| Comment ID              | Reference to EIS   | Result of Review of NexGen Oct 2023 Response | Result of Review of NexGen May 22, 2024 Response +Justification / Rational / Additional Advice to Proponent  | NexGen Response   | Section in EIS |

**ECCC-15**

#### 4.2.4 Evaluation of Selenium in Fish Tissue

**Figure 4-4: Comparison of Predicted Selenium Fish Tissue Concentrations against Criterion**

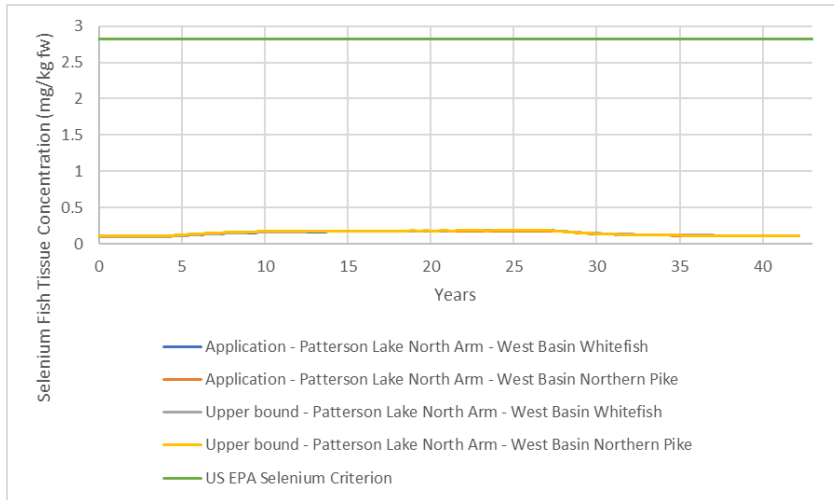
| Comment ID              | Reference to EIS   | Result of Review of NexGen Oct 2023 Response | Result of Review of NexGen May 22, 2024 Response +Justification / Rational / Additional Advice to Proponent  | NexGen Response   | Section in EIS |
|-------------------------|--|--|--|---|----------------|
| ECCC-15<br>Link: IR 84  | TSD XXI ERA Section 4.2.4<br><br>Baseline Annex V.I Aquatic Baseline Section 9.2.1.3, Section 9.2.1.4, Section 9.3.2.2<br><br>Baseline Annex V.I Aquatic Baseline Appendix C Table 49 and Table 51 | NEW Feb 12, 2024                             | <p><b>Justification/Rationale/Advice:</b></p> <p>ECCC appreciates that the Proponent will include relevant context provided in their response to advice comment ECCC 15 in Section 4.2.4 of revised EIS TSD XXI (Environmental Risk Assessment). ECCC recommends that the Proponent also include the supporting information used to derive the bioaccumulation factors (BAF) (i.e., plot that depicts underlying data used to derive BAF).</p>   | <p>NexGen confirms that a figure showing a plot that depicts underlying data used to derive bioaccumulation factors for northern pike and lake whitefish will be added in Section 4.2.4 of Final EIS TSD XXI (Environmental Risk Assessment).</p> <p>NexGen confirms that the updates referenced by the reviewer that were committed to as part of the original response to this Advice to Proponent comment were included in Section 4.2.4 of the revised EIS TSD XXI (Environmental Risk Assessment).</p>   | TSD XXI        |

Predicted fish tissue concentrations of selenium in northern pike and lake whitefish over the Project phases for both the Application Case and Upper Bound sensitivity scenario are shown in Figure 4-4, along with a comparison against the selenium criterion. The selenium bioaccumulation factor (BAF) for northern pike is [a non-linear BAF where  \$BAF = 949x^{0.827}\$  \(x is in units of  \$\mu\text{g/L}\$ \)  \$9.49\text{E}+02 \text{ L/kg fw}\$](#)  and the BAF for lake whitefish is  $5.94\text{E}+03 \text{ L/kg fw}$  based on publicly available regional data from other uranium mine sites in northern Saskatchewan. [Regional measured fish tissue data \(Tables 49 to Table 56 of Appendix C of Annex V.1, Aquatic Environment Baseline](#)

Using the regionally derived lake whitefish BAF, the maximum predicted upper bound selenium concentration is 0.19 mg/kg fw in lake whitefish in Patterson Lake North Arm – West Basin compared to the criterion of 2.83 mg/kg fw. Selenium concentrations in fish at the maximum location in Patterson Lake North Arm – West Basin are all well below the recommended criterion.

Figure 4-5: Development of Regional Bioaccumulation Factors for Selenium in Saskatchewan

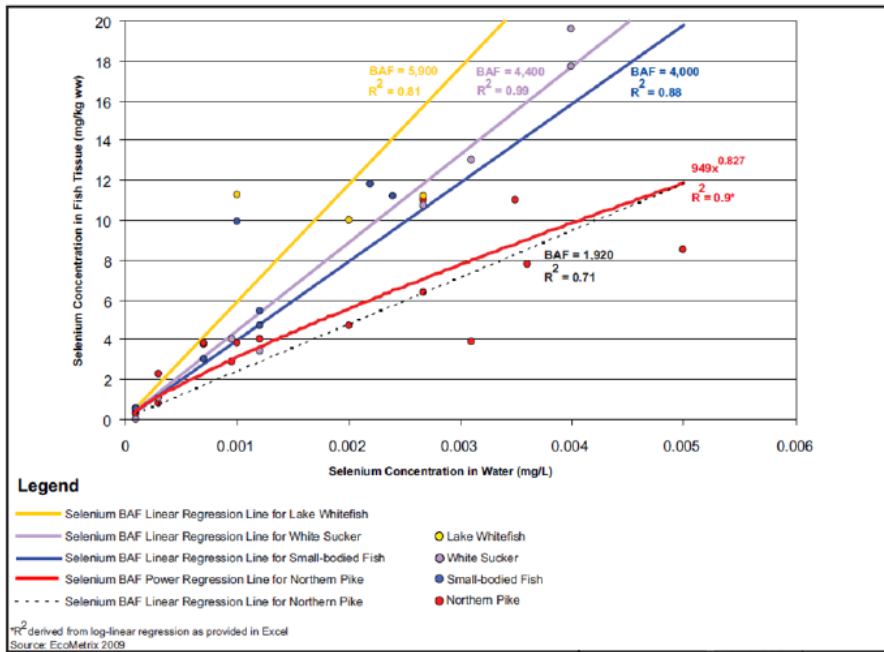
Commented [FH4]: Edits made in response to ECC-15

Report) and measured water concentrations (Table 3.3-1 of Section 3.3.2.3 of Annex V.1) were used to develop the BAFs (see Figure 4-5), which incorporate the selenium bioaccumulation through the food chain. Large- and small-bodied fish tissue data were considered separately because selenium concentrations are based on different tissue analyses for these two groups: wet weight muscle and wet weight whole body, respectively. Tissue data were available for northern pike, cisco, lake trout, longnose sucker, lake whitefish, white sucker, lake chub, and spottail shiner. The data comparisons resulted in the following conclusions:

- The same BAF can be applied to a fish species at different lakes;
- The BAF values for longnose sucker, cisco and lake trout were not significantly different from those for northern pike; therefore, data from these species were combined to derive a BAF for northern pike;
- The BAF values for lake whitefish and white sucker were significantly different ( $p < 0.05$ ) from that for northern pike; and
- The BAF values for lake chub and spottail shiner were not significantly different ( $p > 0.05$ ) from each other; therefore, data for these two species were combined to derive a BAF for small-bodied fish.
